From: [Whited, Jeffrey](#)
To: [Bush, Richard](#)
Subject: New Rifle Draft GCAP RAIs
Date: Monday, June 19, 2017 11:20:04 AM
Attachments: [New Rifle GCAP Request for Additional Information.pdf](#)

REQUEST FOR ADDITIONAL INFORMATION
DRAFT GROUNDWATER COMPLIANCE ACTION PLAN
NEW RIFLE, COLORADO, PROCESSING SITE
DOCKET NO. WM-00062

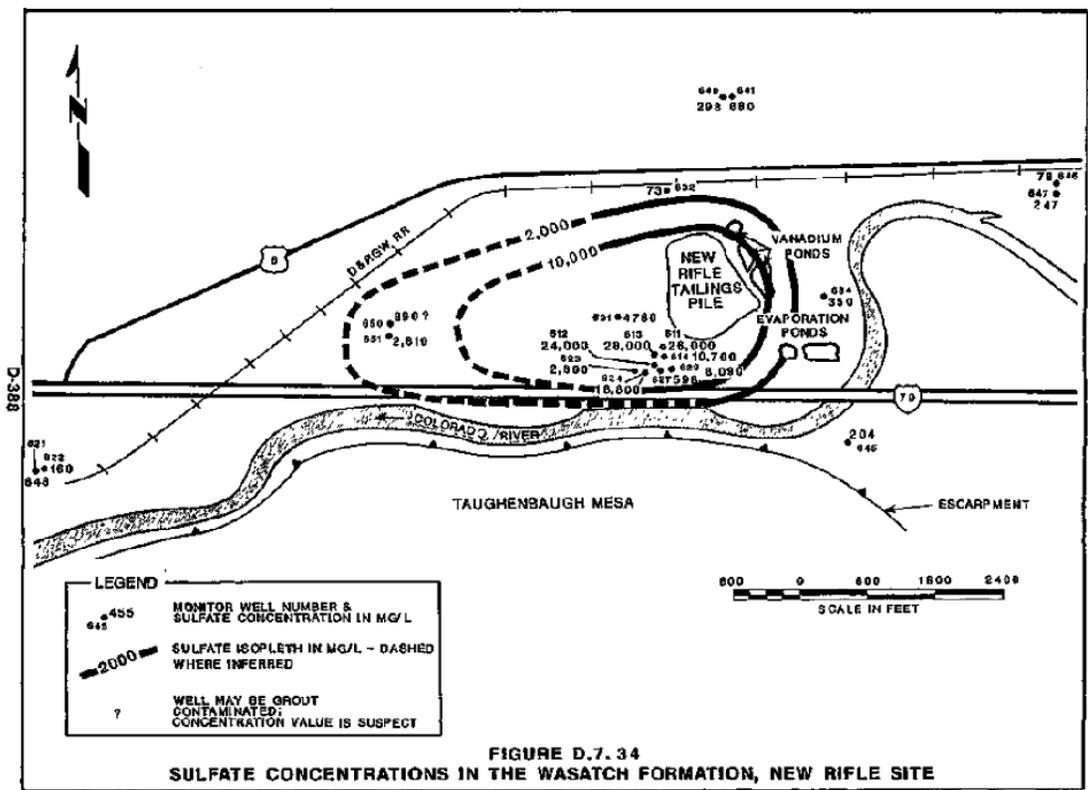
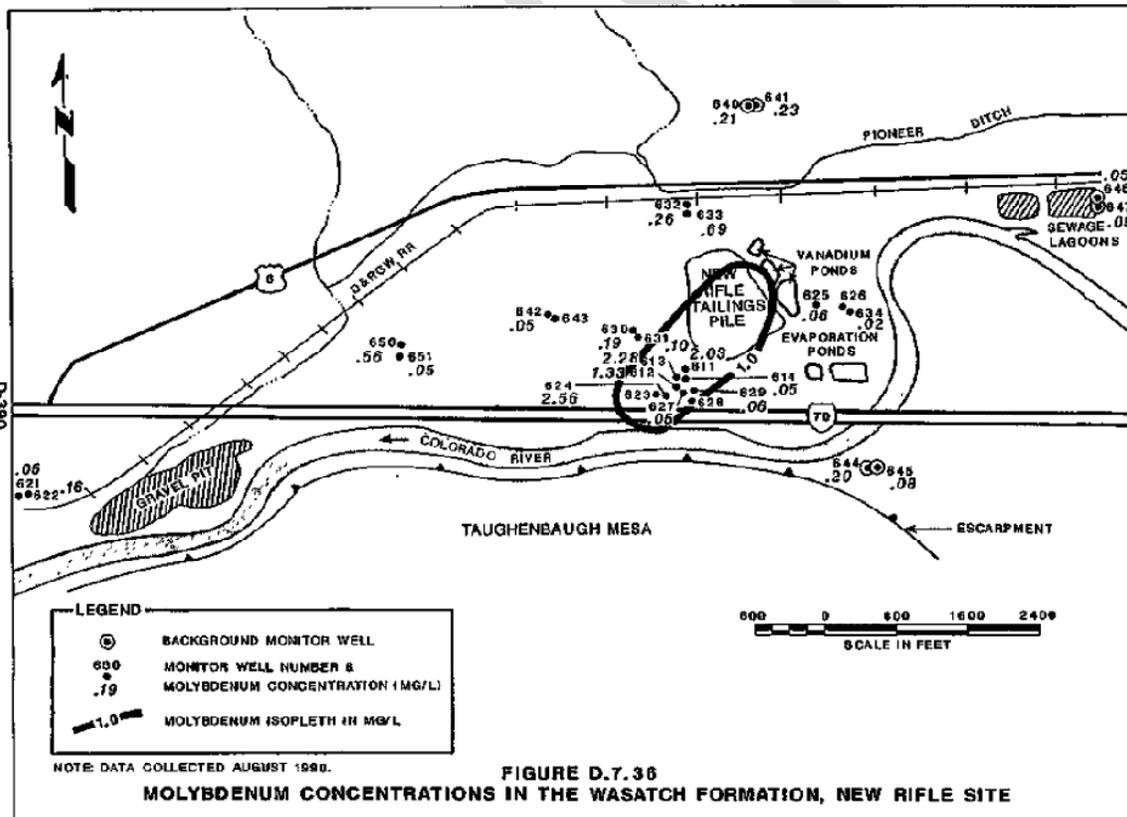
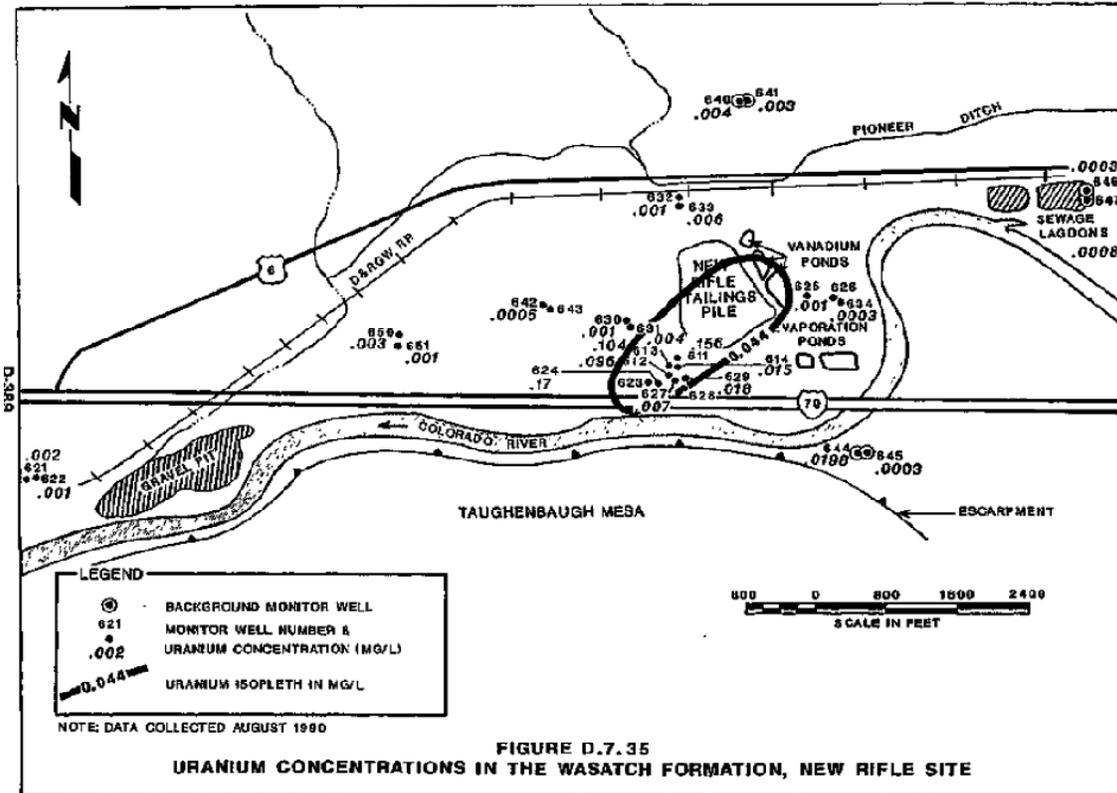
Comment 7: DOE indicated that site field investigations have shown that the alluvial aquifer is the only aquifer affected by the former milling operations (page 15). This conclusion seems to contradict previous characterization data.

Basis: Data from DOE's 1992 remedial action plan (DOE, 1992) shows contamination of the Wasatch formation by a variety of COC's. That document indicates that groundwater was contaminated to depths of 27 m [90 ft] and distances of 1100 m [3500 ft]. The figures below provide isopleths for sulfate, uranium, and molybdenum. In the case of uranium and molybdenum, it appears there is limited characterization data to estimate contaminant concentrations south of interstate 70 from the previous location of the tailings pile. The closest well is 0217, which showed the second highest uranium value in the alluvium [0.13 mg/L] as of November 2015 in Figure B-2 of the draft GCAP. DOE indicated that the Shire Member (uppermost layer of the Wasatch Formation) is hydraulically connected to the overlying alluvium though flow is not dominant from one unit to the other. During milling operations, very large quantities of water were used compared to the present day, which may confound the development of a conceptual model to describe the extent of groundwater contamination. High water usage may have driven contamination much deeper in the system than would be anticipated by present day hydrologic measurements.

Path Forward: Provide a description of monitoring data collected for the Shire and Molina Members of the Wasatch Formation. Reconcile the characterization data presented in the 1992 remedial action plan with the present day GCAP summary. If necessary, revise the monitoring network, and POE locations and analysis to account for contamination of the Wasatch Formation.
